For discussion TFKT/08/2011

Kai Tak Development Urban Design Enhancement Proposals

PURPOSE

The purpose of this paper is to brief Members on the proposed urban design enhancement for Kai Tak Development (KTD) to be taken forward.

Proposed Relocation of Roads and the Associated Landscaped Deck at Runway away from the Waterfront

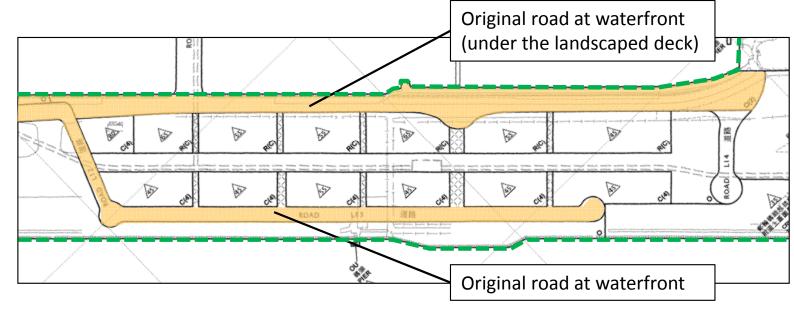
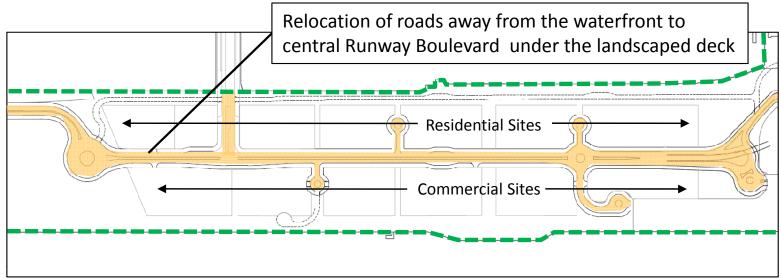
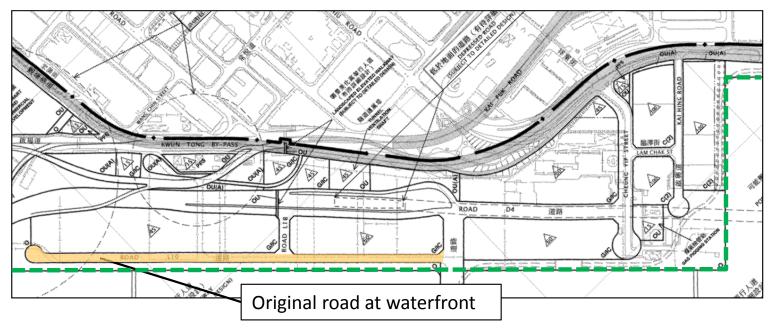
- 5. We now propose relocating two planned roads and the associated landscaped deck away from the waterfront to the central Runway Boulevard to enhance public accessibility and enjoyment. Due to the existence of at-grade vehicular connections to the Cruise Terminal and the underground infrastructure for the District Cooling System, the relocated road will be designed as an at-grade carriageway with connections to planned residential and commercial developments, the Cruise Terminal as well as the Metro Park and the Runway Park. Similar to the original arrangement, a landscaped deck will be provided above the road at the central Runway Boulevard which will serve as an open space and a walkway, as well as an effective traffic noise mitigation barrier for adjoining residential developments.

- 6. We propose widening the Runway Boulevard from 32m to 36m to accommodate more tree-planting. As for the promenades, we propose to maintain the total width of the promenades as shown on the approved OZP. The promenade facing the Victoria Harbour will be about 35m wide to accommodate more active recreational uses and major activities nodes to complement the vibrant atmosphere of the commercial development. The promenade facing the Kai Tak Approach Channel will be about 25m wide to provide a comfortable setting for passive leisure uses in the tranquil residential setting. The resulting area of "Open Space" would be similar to that shown on the approved OZP.

- 7. As a result of the above changes, the boundaries of the development sites at the Runway Precinct would have to be adjusted. While there will be slight increase in both domestic and non-domestic Gross Floor Area (GFA), it will be comparable to the original development intensity. (See **Annex 1**)

Proposed Relocation of Road at South Apron away from the Waterfront

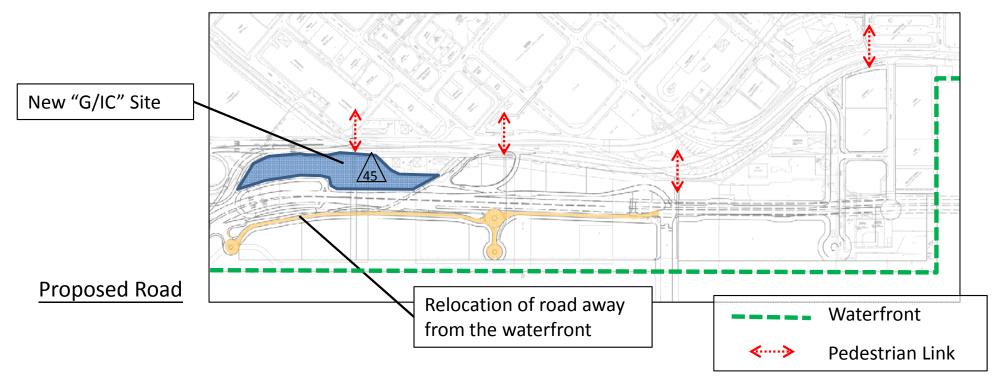
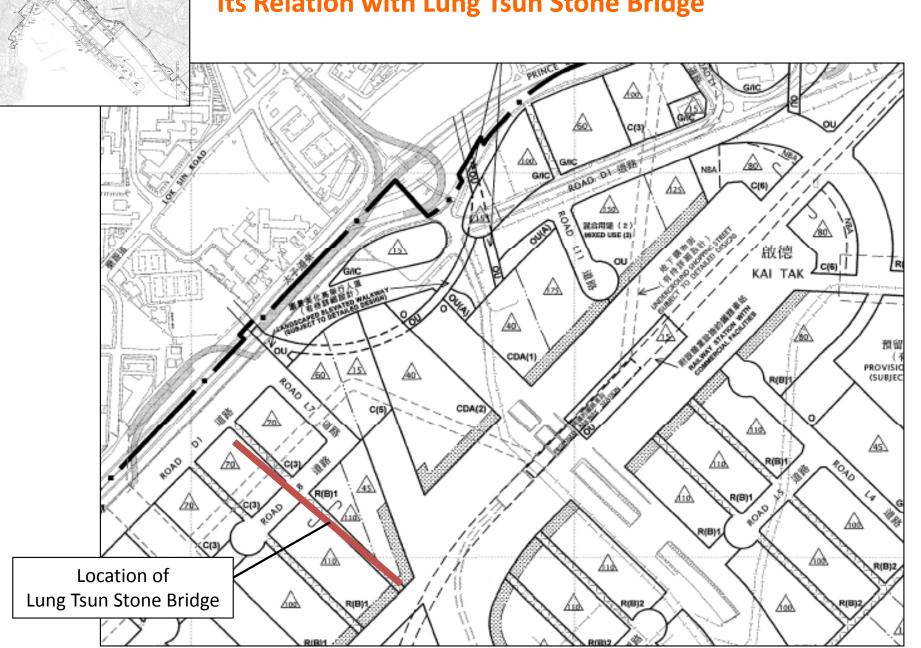
- 8. We presented Paper No. TFKT/07/2010 at the third meeting of the Task Force in January 2011, on the conceptual enhancement of accessibility to South Apron waterfront being pursued.
- 9. After further investigation, we now propose relocation of the planned local road along the waterfront to an area next to Trunk Road T2 to enhance public accessibility and enjoyment. Pedestrian links will be extended to enhance connectivity with the Kowloon Bay hinterland. The layout of road interchange is also refined, as described in Paper No. TFTK/07/2010, to minimise visual intrusion caused by above-ground structures.

10. Opportunity is also taken to merge a number of amenity areas south of Kai Fuk Road opposite the Hong Kong International Trade and Exhibition Centre and rezone as "Government, Institution or Community" ("G/IC") use (about 1.7 hectares) (See **Annex 2**).

Proposed Enhancement in Connection with Preservation of Lung Tsun Stone Bridge

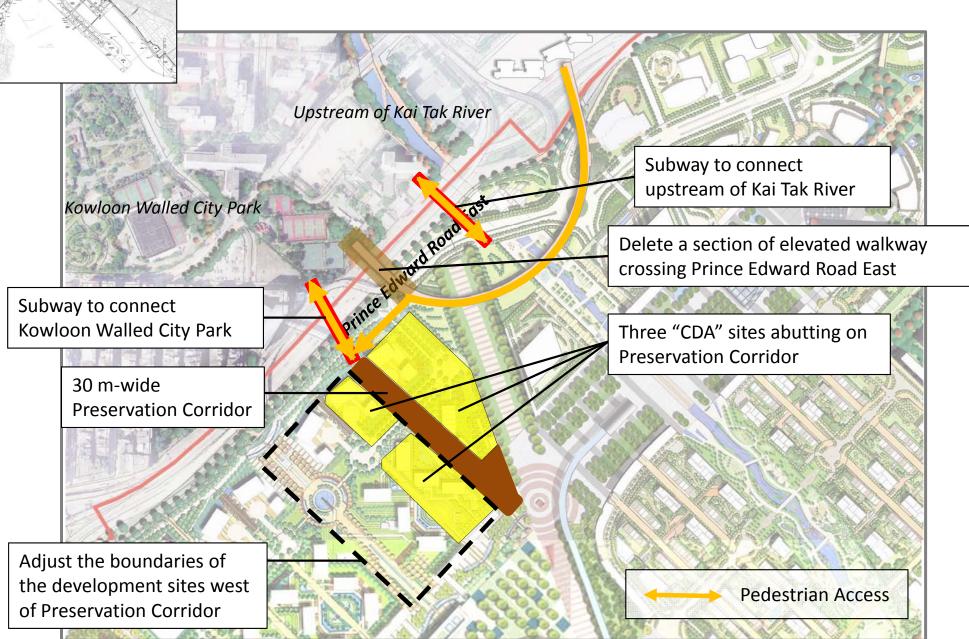
- During the public engagement, the public generally accepted having a preservation corridor of not less than 25m wide to provide adequate space for appreciation of the Bridge remnants and the display of associated interpretative facilities. To allow greater design flexibility, we now propose to provide a 30m-wide preservation corridor and zone it together with a plaza at its southern end connecting with the Station Square as "Open Space" ("O"). A subway is proposed across the Prince Edward Road East (PERE) in lieu of the PERE section of the planned elevated landscaped walkway in the approved OZP, to connect the preservation corridor to Kowloon City and hence other cultural resources, especially Kowloon Walled City Park. The boundaries of the development sites in the vicinity of the preservation corridor will be The three development sites abutting the corridor are proposed to be rezoned as "Comprehensive Development Area" ("CDA") to ensure harmony in design and layout through statutory mechanism. The enhancement in connection with preservation of Bridge remnants is at **Annex 3**.

Proposal to Reinforce Gateway Image and Provision of a Large Landscaped and Community Area for Arts and Performance

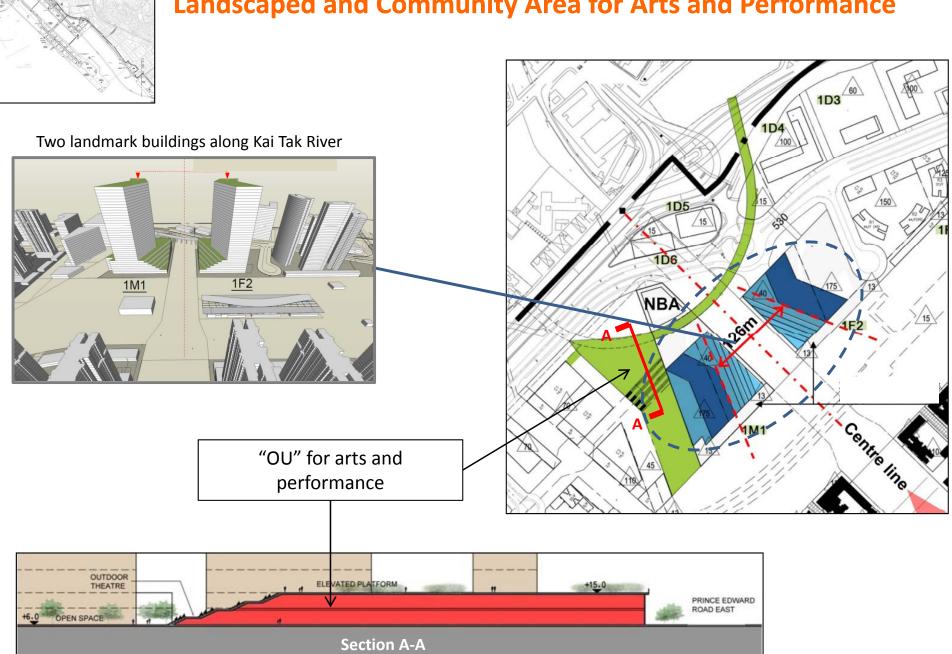
- 13. In connection with the above key proposals, we propose other refinements described below that will further enhance the gateway image in the Kai Tak City Centre and to maintain the overall development scale of Kai Tak.
- 14. In line with development of the cruise terminal, 39,400m² of non-domestic GFA of the previously planned 50,000m² in the cruise terminal site is proposed to be transferred to the adjoining Tourism Node so that its overall non-domestic GFA is increased to 229,400m².
- 15. At the Kai Tak City Centre, we propose to merge the planned elevated landscaped walkway with a commercial site and rezone it as "Other Specified Uses" ("OU") for arts and performance-related uses.

The original commercial GFA will be transferred to a "CDA" site west of Kai Tak River, forming a twin-tower gateway together with the landmark building in the "CDA" site east of Kai Tak River (See **Annex 4**). The domestic and non-domestic plot ratios of the two "Other Specified Uses (Mixed Use)" sites will be adjusted to accommodate the domestic GFA displaced by the Bridge preservation corridor. For the Grid Neighbourhood sites, we propose to enhance the urban design with the concept of having high and low residential blocks with central courtyard (See **Annex 5**). Regarding the Underground Shopping Street connecting to Kowloon City, we suggest to align it to connect to the two proposed stations of the Shatin-to-Central Link located in the Kai Tak City Centre.
